Heathridge Park

HEATHRIDGE PARK MASTERPLAN - CONCEPT DESIGN - OPTION 2

Proposed concept design amendments – Heathridge Park masterplan

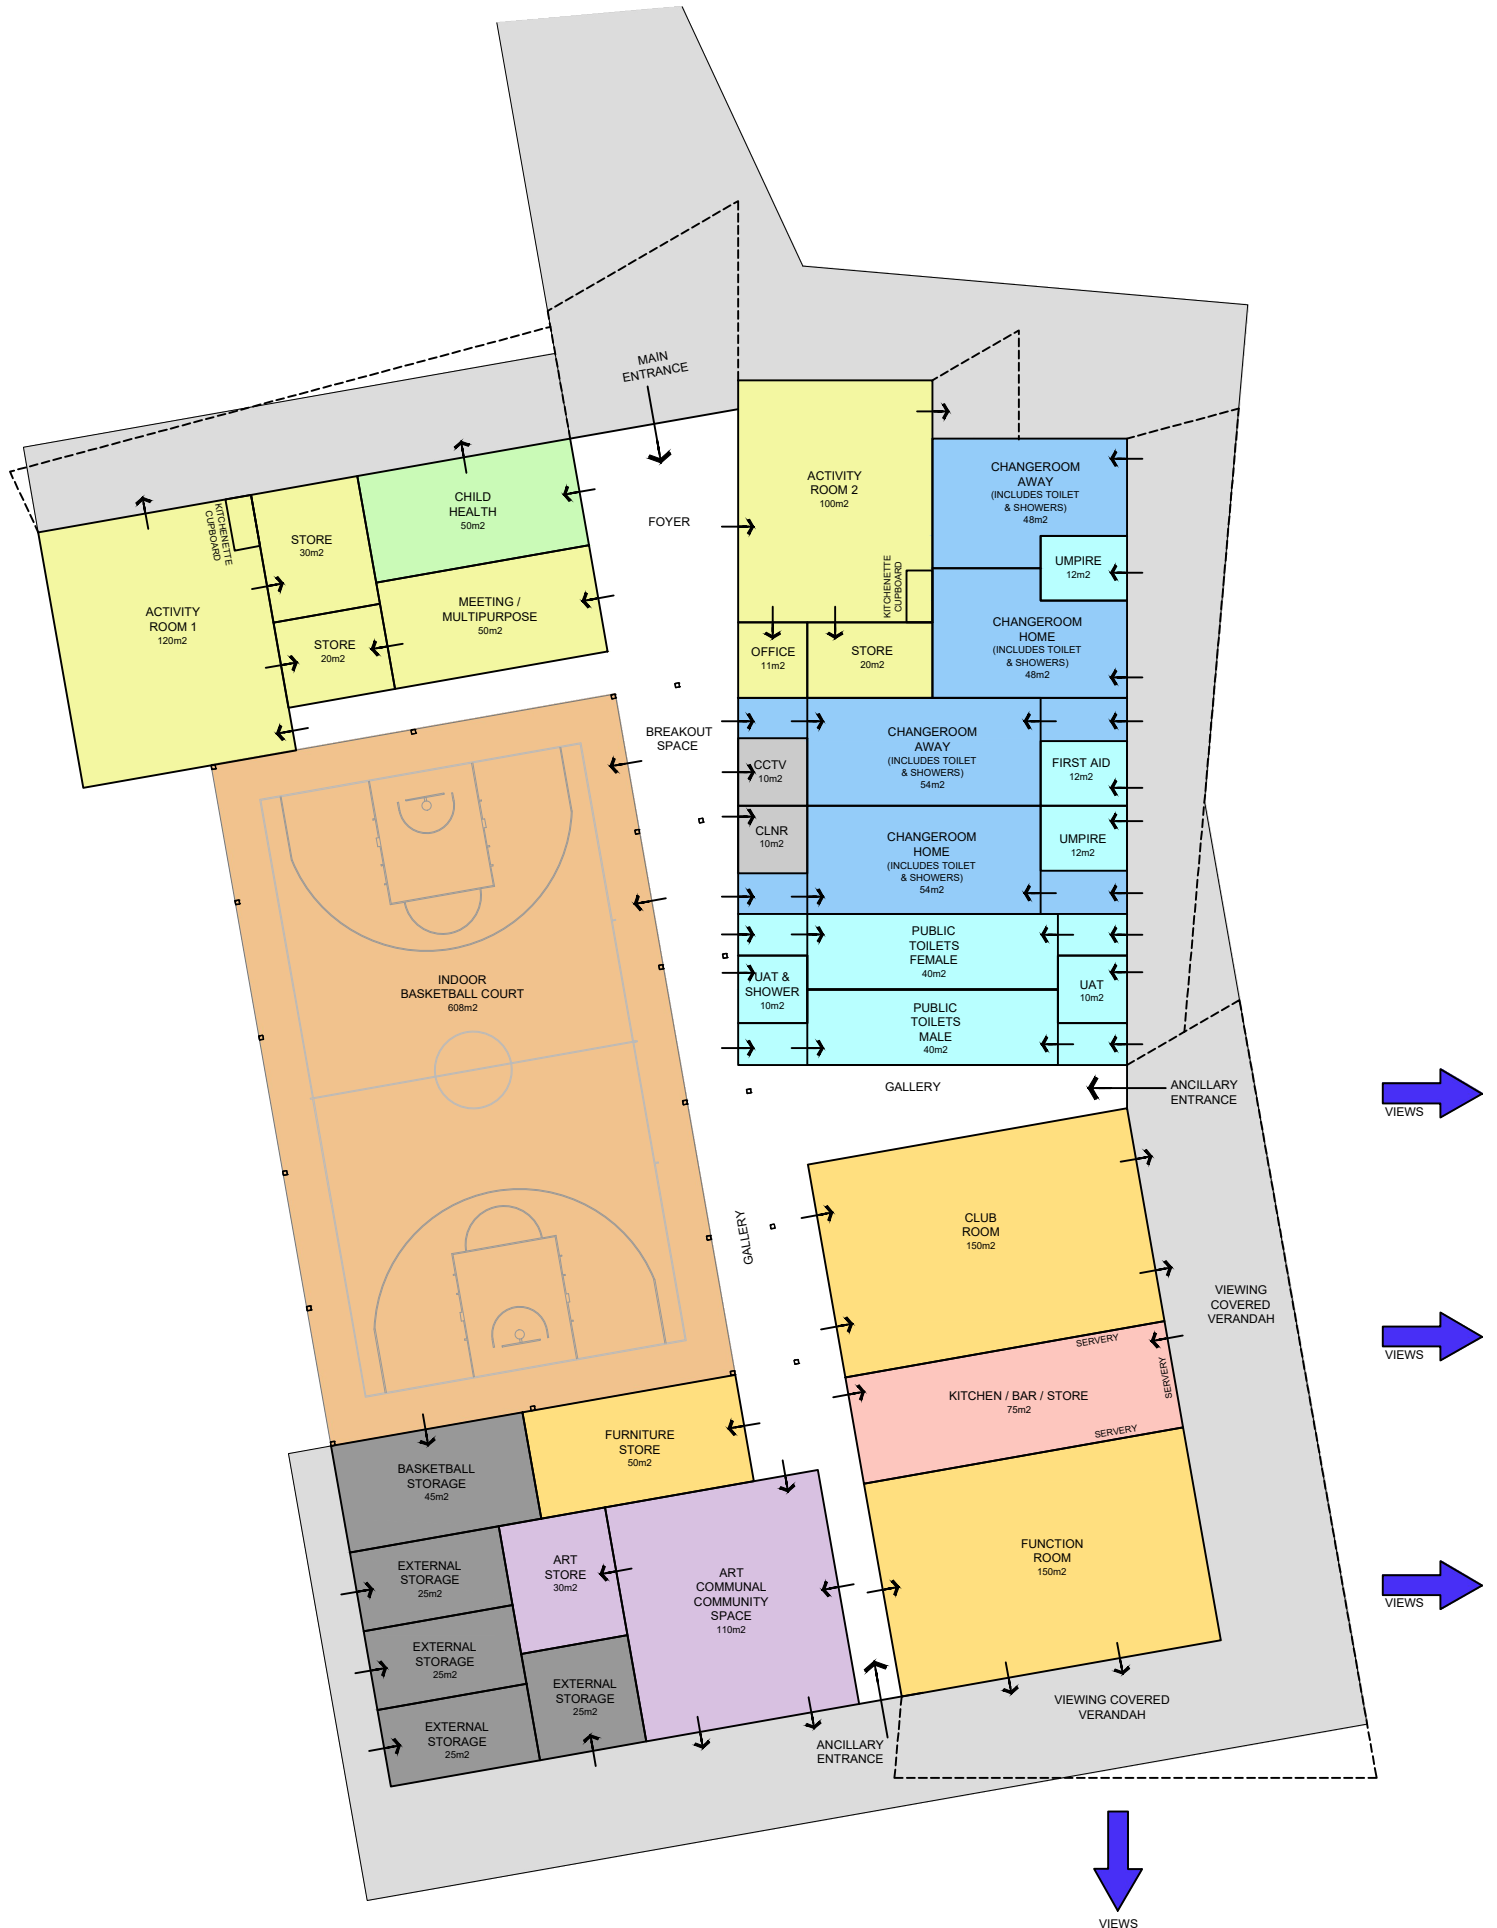
Component	Included in previous concept designs	Proposed amendments	Comment
Car parking (item 1 / 18 on concept design)	No additional car parking included.	Additional car parking to be included.	There is insufficient car parking around the park. Currently, on games days for the sporting clubs, the existing car parks are at capacity. Additional parking is to be included near the proposed new building and in the area where the existing Heathridge Community Centre is located. Vehicle access between car parks is also to be considered.
Building design (item 2 / 3 on concept design)	Limited number of rooms included in the design.	Additional rooms added to the design.	The review of bookings data identified that additional spaces are required due to an increase in usage by community groups. Additional spaces are also required for user group storage due to the increase in usage, and to meet the City's standard provision for community and sporting facilities. A review of the City's standard provision identified that additional features were required.

Second AFL oval (item 4 / 5 on concept design)	Expansion of sports playing field area to accommodate a second AFL oval.	Sports playing field not to be expanded. Sports floodlighting to be retained in existing locations.	Expansion of the sports playing field to accommodate a second AFL oval would require: • Relocation of the existing drainage site which would result in additional costs. • The removal of mature trees. • An upgrade of the sports floodlighting which would result in additional costs.
Tennis courts (item 6 on concept design)	Six new tennis courts included.	Eight tennis courts included.	The Ocean Ridge Tennis Club has advised that six courts are not sufficient for existing and future operations. Tennis West have indicated that eight courts are required to host inter-club competitions. The community consultation undertaken in late 2020 indicated that 37.5% of respondents supported or strongly supported the reduced number of courts, and 37.5% of respondents opposed or strongly opposed the reduced number of courts. A further 19.4% of respondents indicated that they were neutral (the remaining 5.6% of respondents did not provide a response to this question).

Basketball pad (item 7 on concept design)	Basketball pad close to the new building.	Basketball pad relocated to alternate location.	The half court basketball pad is proposed to be located approximately 60 metres from residents on the previous concept design. The draft Department of Water and Environmental Regulation (DWER) guidelines will require outdoor basketball courts to be located at least 90 metres from residents to help minimise the impact of noise on residents, so the basketball pad will be relocated accordingly.

Component	Included in previous concept designs	Proposed amendments	Comment
Cricket nets (item 8 on concept design)	Four new cricket nets included.	Existing cricket nets to be retained. New lighting to be provided.	The relocation of the cricket nets was required to accommodate a second AFL oval. The removal of these works means that the existing cricket nets can be retained and upgraded with new lighting. The community consultation undertaken in late 2020 indicated that 53.7% of respondents supported or strongly supported the relocated cricket nets, and 6% of respondents opposed or strongly opposed the relocated cricket nets. A further 31.9% of respondents indicated that they were neutral (the remaining 8.4% of respondents did not provide a response to this question).
Informal amphitheatre / event space (item 11 on concept design)	Terraced seating and informal stage included.	Design of informal amphitheatre / event space to be scaled back.	There is no requirement for a stage / amphitheatre in this area as the park is already utilised for outdoor events and will provide sufficient event space in the future, if required. The proposed location is in close proximity to residents and may create noise issues. It is proposed to scale back the design of the amphitheatre / event space. The community consultation undertaken in late 2020 indicated that 56.9% of respondents supported or strongly supported the informal amphitheatre / event space, and 11.1% of respondents opposed or strongly opposed the informal amphitheatre / event space. A further 23.6% of respondents indicated that they were neutral (the remaining 8.4% of respondents did not provide a response to this question).

Drainage site (item 14 / 15 on concept design)	New drainage included.	Retention of the existing drainage site.	The relocation of the existing drainage was required to accommodate a second AFL oval. The removal of these works means that the existing drainage area can be retained.
